**METROPOLITAN GOVERNMENT OF NASHVILLE AND DAVIDSON COUNTY**

**STAFF RECOMMENDATION**  
**303 North 16<sup>th</sup> Street**  
**October 16, 2013**

**Application:** New construction – outbuilding; Setback reduction  
**District:** Lockeland Springs-East End Neighborhood Conservation Zoning Overlay  
**Council District:** 06  
**Map and Parcel Number:** 08310014900  
**Applicant:** Mike & Lauren Presley  
**Project Lead:** Melissa Baldock, melissa.baldock@nashville.gov

Figures 2 & 3. The garage will be built on top of an existing concrete pad.

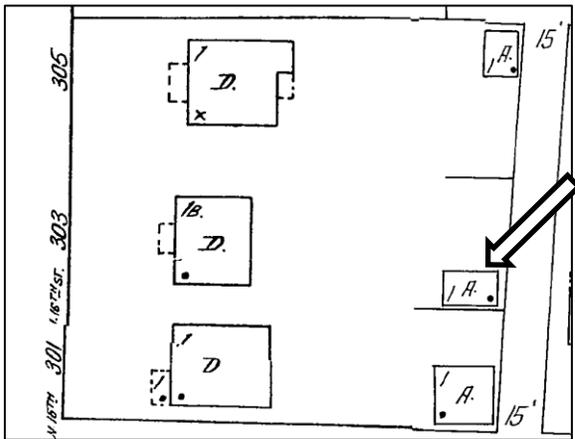
Location, Setbacks. The applicant is proposing to construct a one-story, one bay outbuilding at the rear of the property, on top of an existing concrete pad (Figures 2 & 3 on next page). The garage will be more than twelve feet (12') from the rear property line, meeting the rear setback. The existing concrete pad sits approximately one foot (1') from the right side property line, but base zoning requires a three foot (3') setback. The garage therefore requires a setback reduction for the side. Staff finds that the side setback reduction is appropriate in this instance for several reasons. Historically, outbuildings were often located close to, or even on, the property lines. A 1951 Sanborn Map shows that an accessory structure in almost the exact location as the one proposed, which also does not meet the three foot (3') side setback requirement (Figure 4 on next page). In addition, the modest one-story, one-bay size of the garage will help minimize the impact of the reduced setback.

Staff finds the setbacks and location meet Sections II.B.3 and II.B.8 of the *Lockeland Springs-East End Neighborhood Conservation Zoning Overlay: Handbook and Design Guidelines*.

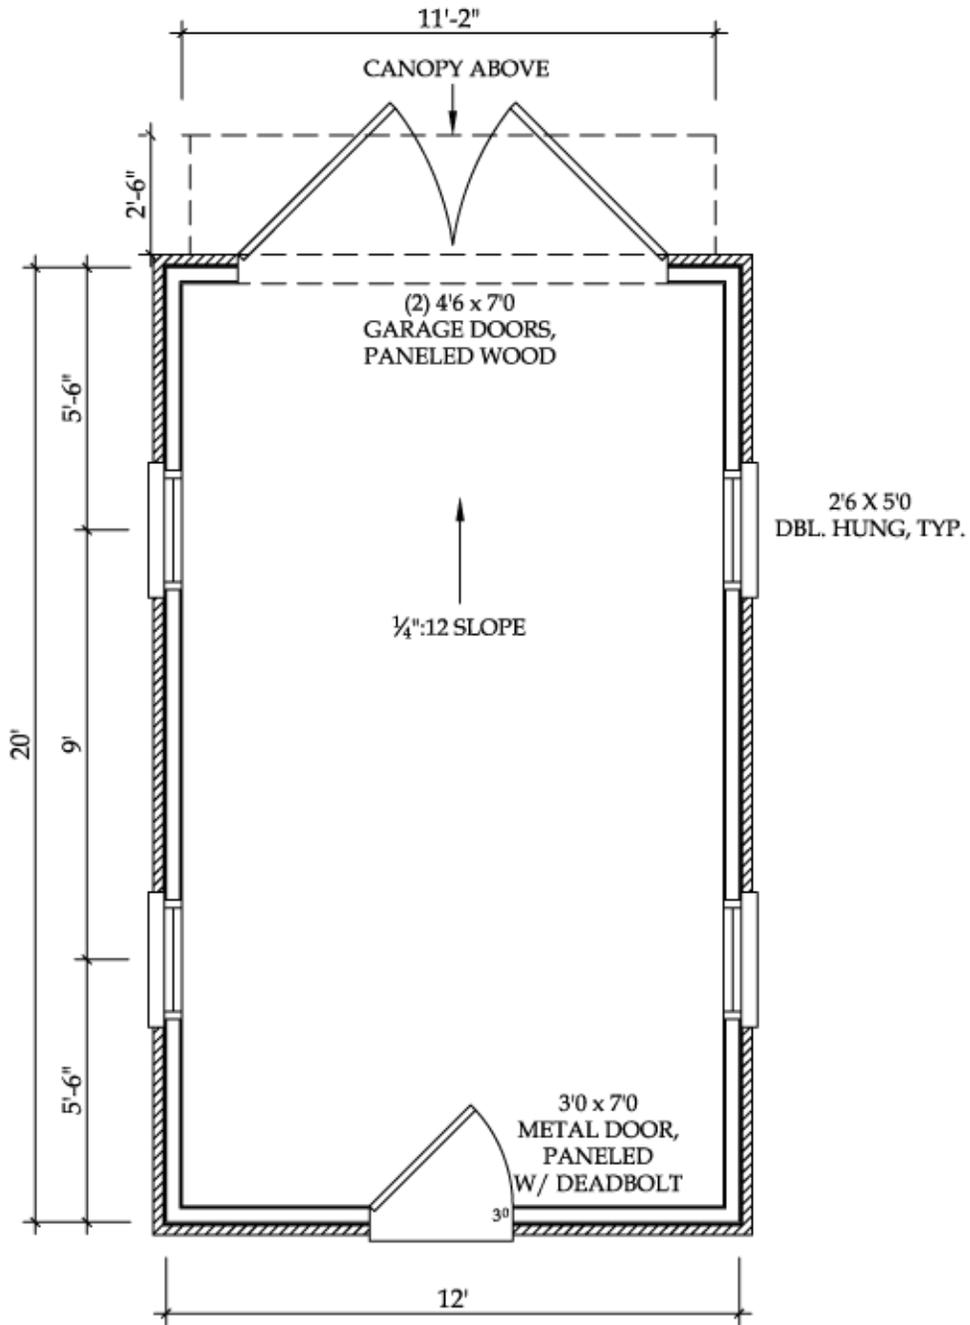
Height Scale. The proposed accessory structure will be one-bay and twelve feet by twenty feet (12' X 20'). It will have a total footprint of two hundred and forty square feet (240 sq. ft.), which is modest. The garage will be one story in height, with an eave height of eight feet (8') from grade and a ridge height of approximately thirteen feet (13') from grade. The garage is sufficiently subordinate in height and scale to the historic primary structure. Staff therefore finds that the height and scale of the outbuilding meets Sections II.B.1, II.B.2., and II.B.8 of the *Lockeland Springs-East End Neighborhood Conservation Zoning Overlay: Handbook and Design Guidelines*.

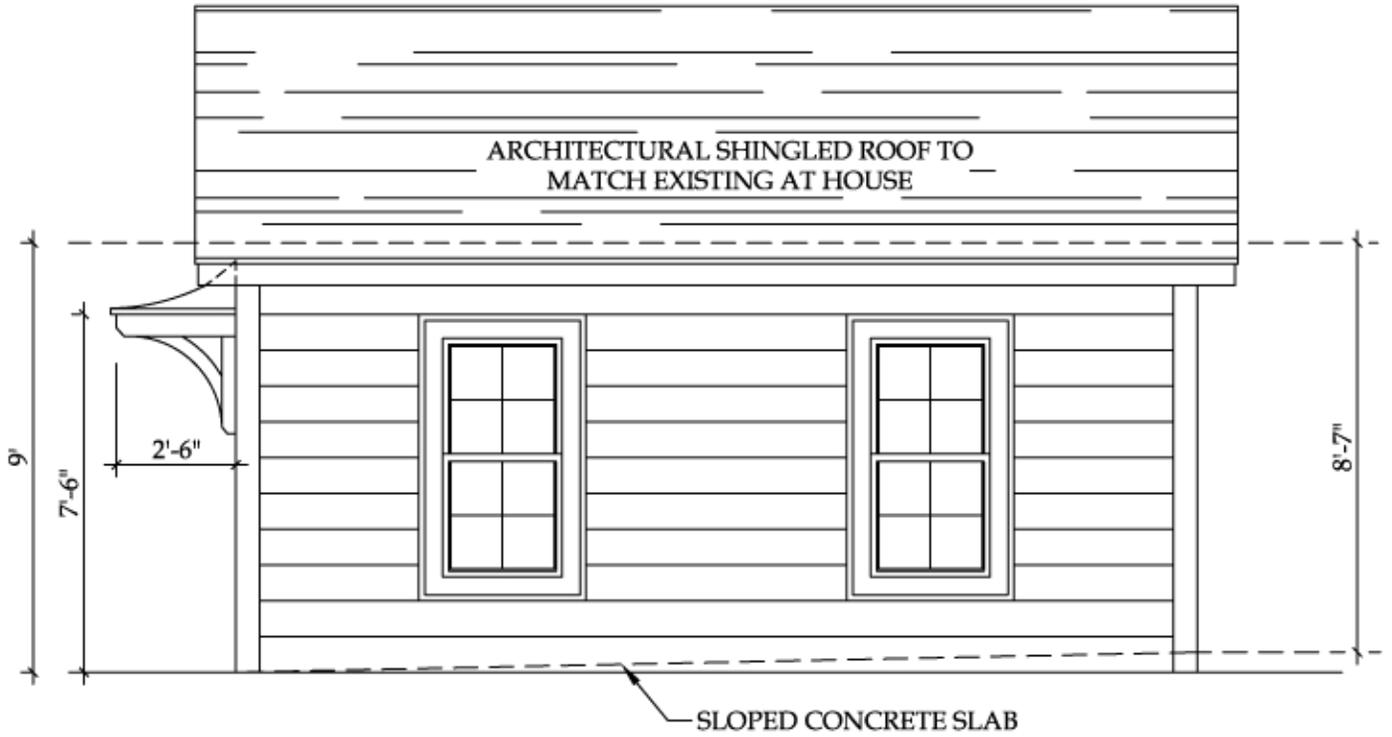
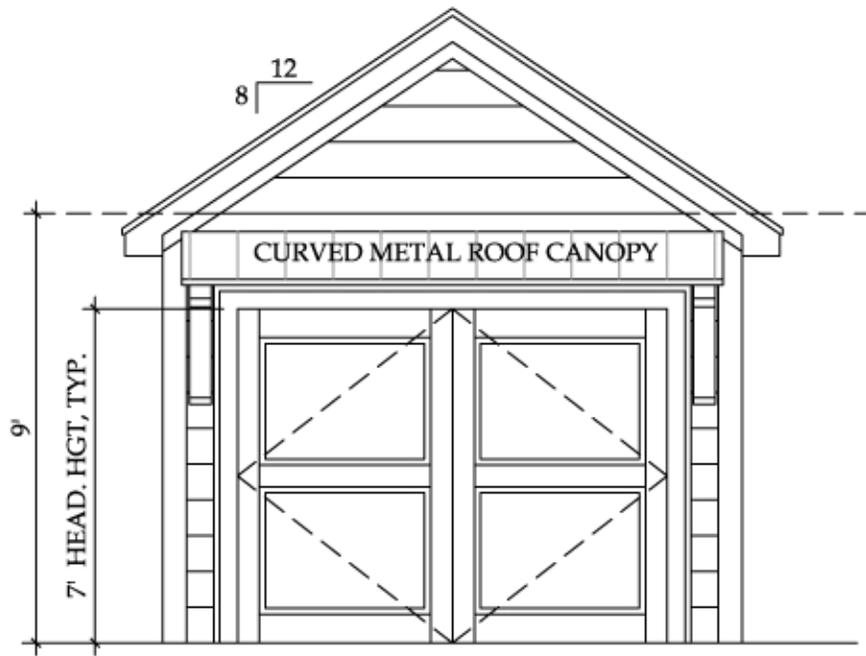
Materials. The exterior materials will include fiber cement siding. Staff asks that the reveal of the siding be a maximum of five inches (5"). The foundation will be a concrete slab, and the roof will be architectural shingles in a color to match the house's shingles. The vehicular door will be wood, and the pedestrian door will be paneled metal. The materials of the windows were not specified, and staff asks to approve all windows and doors prior to purchase and installation. Over the vehicular door will be a curved metal canopy roof, and staff asks to approve the color of the metal. With staff's final approval of the cement fiberboard reveal, the windows and doors, and the roof color, Staff finds that the materials meet Sections II.B.4. and II.B.8 of the *Lockeland Springs-East End Neighborhood Conservation Zoning Overlay: Handbook and Design Guidelines*.

Roofs. The outbuilding's roof will be a front gable with a 8/12 pitch. Staff finds that the outbuilding's roof form is compatible with that of the primary structure and other outbuildings in the area, and meets Sections II.B.5. and II.B.8. of the *Lockeland Springs-East End Neighborhood Conservation Zoning Overlay: Handbook and Design Guidelines*.

**Recommendation Summary:** Staff recommends approval of the outbuilding and the setback reduction with the conditions that the cement fiberboard have a maximum reveal of five inches (5"), and staff approve the final window and door selections and the roof color. With these conditions, staff finds that the outbuilding meets Section of the *Lockeland Springs-East End Neighborhood Conservation Zoning Overlay: Handbook and Design Guidelines*.
